REQUEST FOR INFORMATION

Waitsfield BRF 013-4(39) - Bridge No. 177; VT 100 over Mad River
Waitsfield, VT

RFI #12: Abutment #2: Stem wall PC5, tack welding rebar

1 REINFORCING PLAN VIEW IN FORM

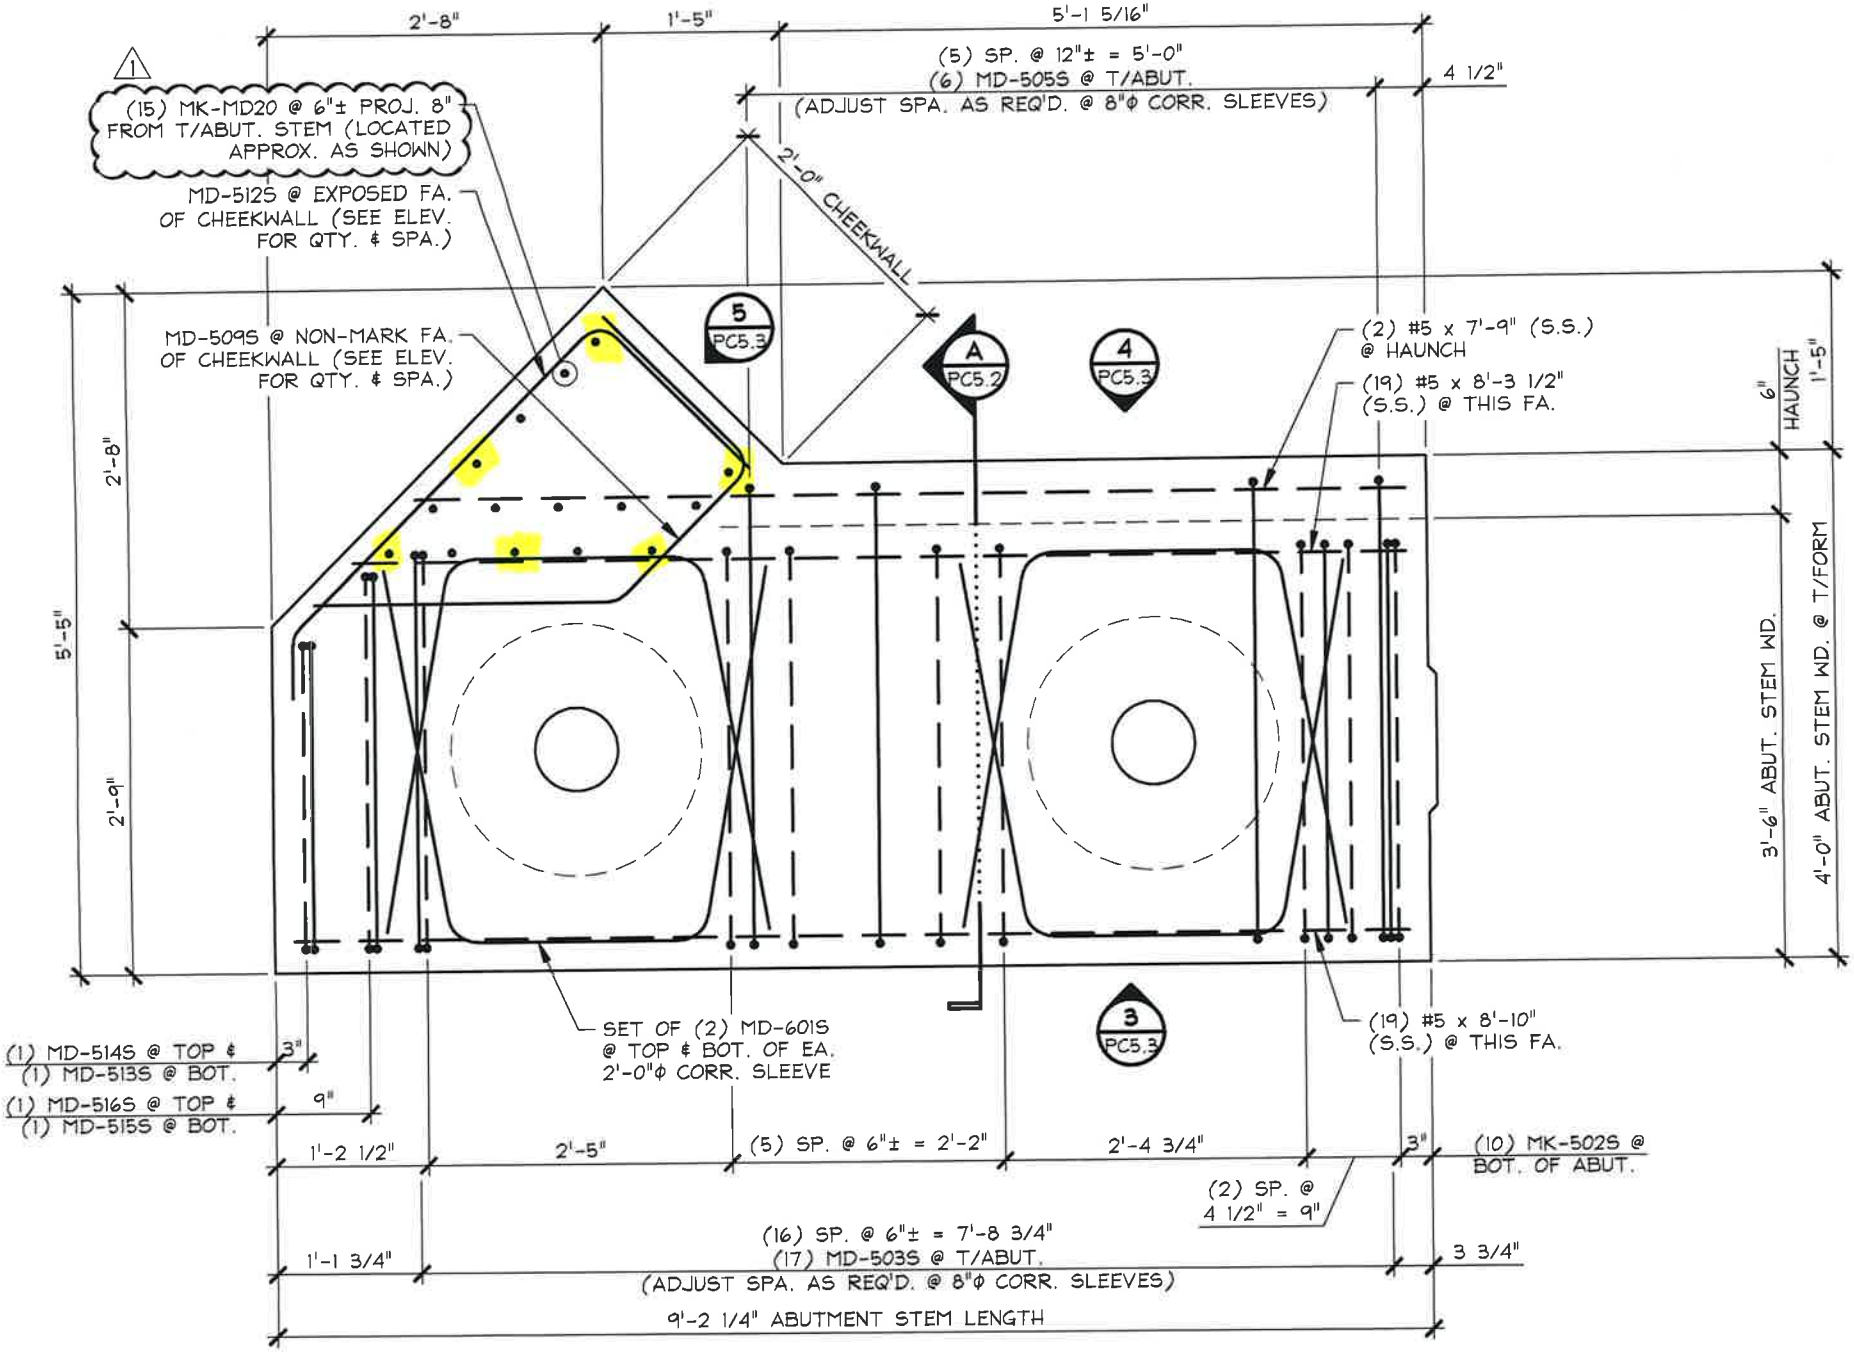
JPC requests permission to tack weld reinforcing rebar in the wing portion of the unit PC5 at the highlighted intersections on the attached details.
